APPLICATION NO.	FILING DATE	FIRST NAMED INVENTOR	ATTORNEY DOCKET NO.	CONFIRMATION NO.
10/618,200	07/10/2003	Ying-Che Huang	03171-URS	4173

<b>Office Action Summary</b>	<b>Application No.</b> 10/618,200	<b>Applicant(s)</b> HUANG ET AL.	
	<b>Examiner</b> William H. Rodriguez	<b>Art Unit</b> 3746

## DETAILED ACTION

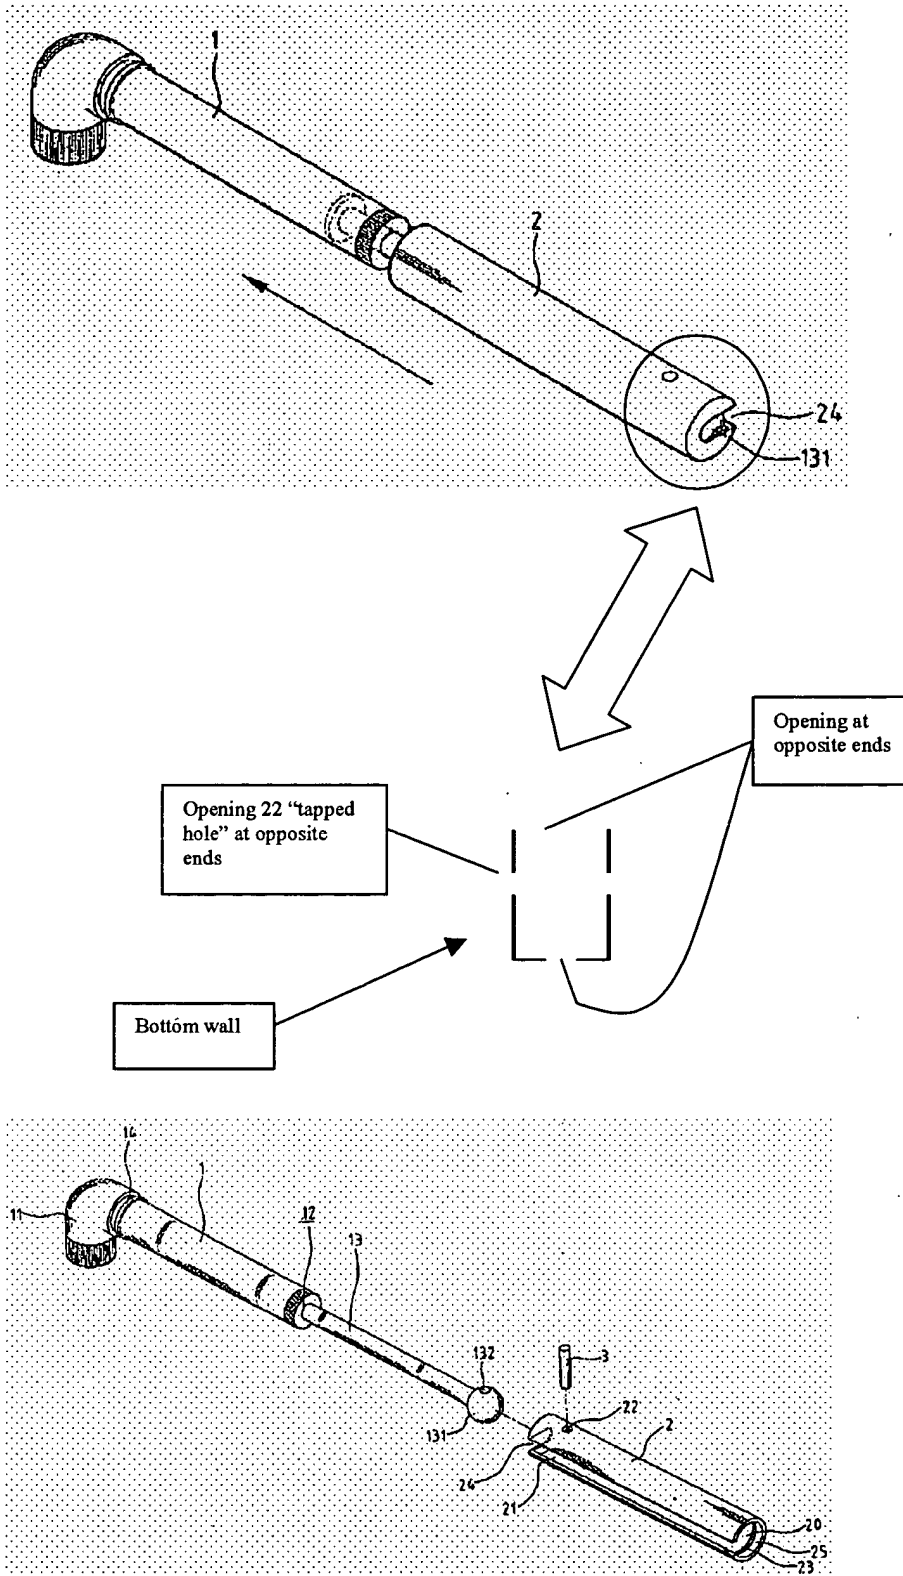
2. **Figure 5 should be designated by a legend such as --Prior Art--** because only that which is old is illustrated. See MPEP § 608.02(g). Corrected drawings in compliance with 37 CFR 1.121(d) are required in reply to the Office action to avoid abandonment of the application. The replacement sheet(s) should be labeled "Replacement Sheet" in the page header (as per 37 CFR 1.84(c)) so as not to obstruct any portion of the drawing figures. If the changes are not accepted by the examiner, the applicant will be notified and informed of any required corrective action in the next Office action. The objection to the drawings will not be held in abeyance.

4. Claim 1 is rejected under 35 U.S.C. 102(b) as being anticipated by **Prior Art Figure 5**.

With respect to claim 1, **Prior Art Figure 5** teaches a collapsible handgrip for inflator, comprising: an air cylinder A having a shaft B connected with a piston (not shown but inherent), in which a stud (not shown but inherent\*) arranged at one end of the shaft extends out of the

cylinder; and a handgrip D which is a hollow tubular body having a bottom wall and an opening at the opposite end, in which a tapped hole C is formed in the bottom wall for locking the stud and storing the cylinder in the handgrip, and the stud is also meant to be locked to the tapped hole through the bottom wall of the handgrip for extending the length of the shaft. See particularly **Figure 5** above.

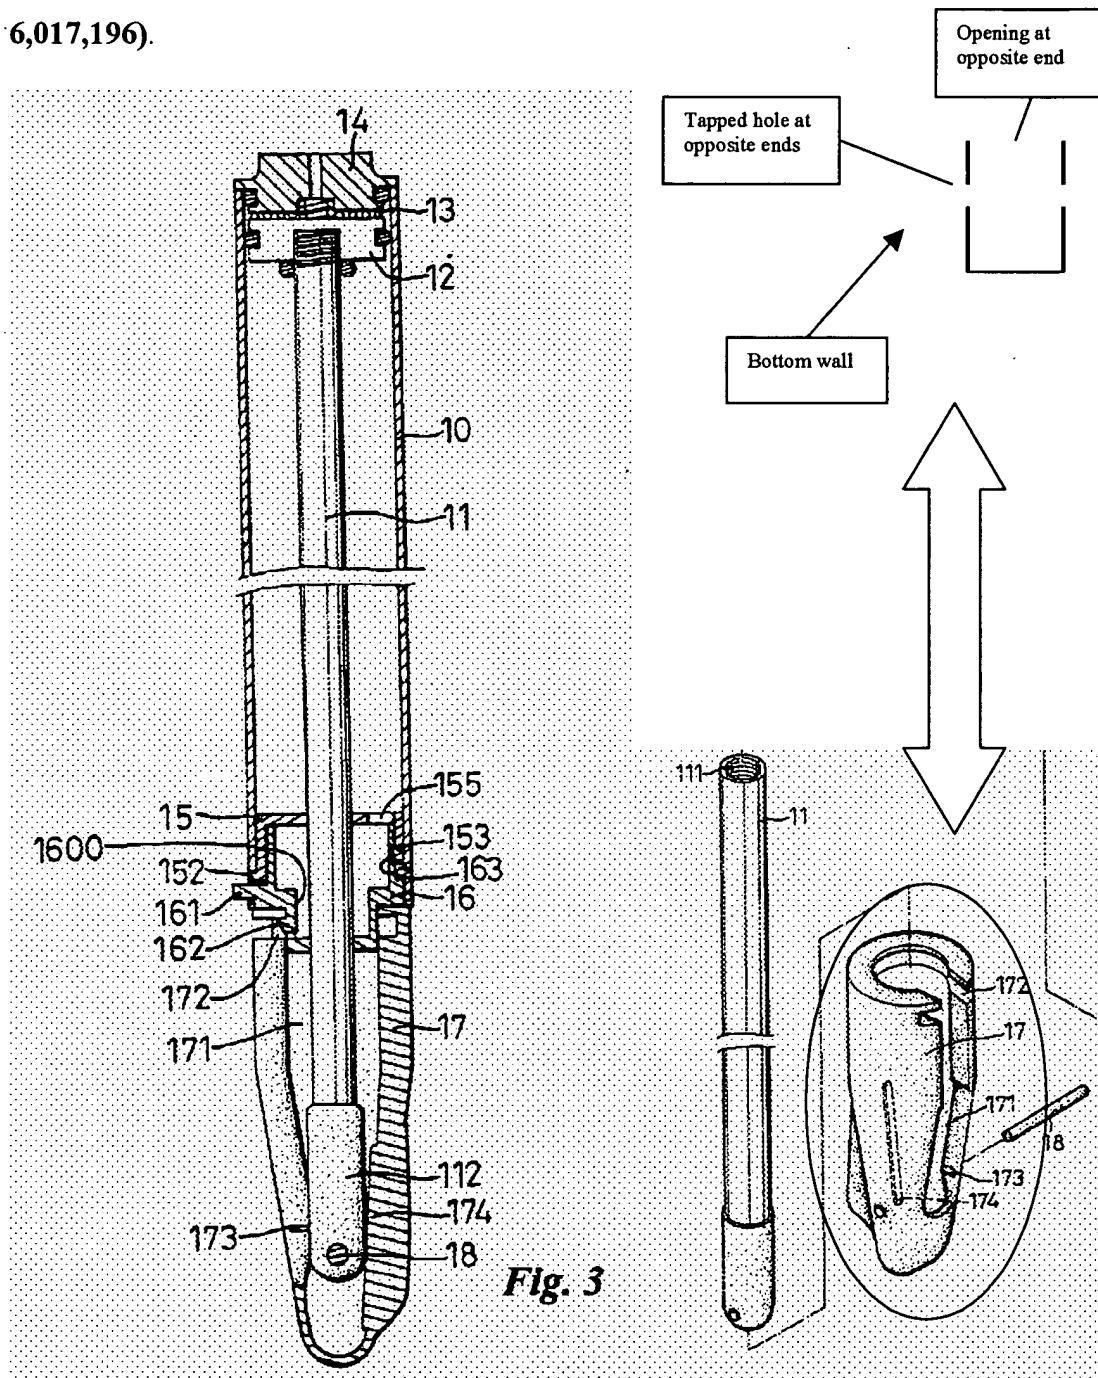
With respect to claim 1, **Huang** teaches a collapsible handgrip for inflator, comprising: an air cylinder 1 having a shaft 13 connected with a piston (not shown but inherent), in which a stud 131 arranged at one end of the shaft extends out of the cylinder; and a handgrip 2 which is a hollow tubular body having a bottom wall and an opening at opposite ends, in which a tapped hole 22 is formed in the bottom wall for locking the stud and storing the cylinder in the handgrip, and the stud is also meant to be locked to the tapped hole through the bottom wall of the handgrip for extending the length of the shaft. See particularly **Figures 1-4**.

With respect to claim 3, **Huang** teaches that the collapsible handgrip further comprises a flange 14 that is formed on an outer surface of the cylinder and a groove 23 is formed in an inner wall of the handgrip such that the flange is engageable to the groove for fixing the cylinder in the handgrip. See particularly **Figure 1**.
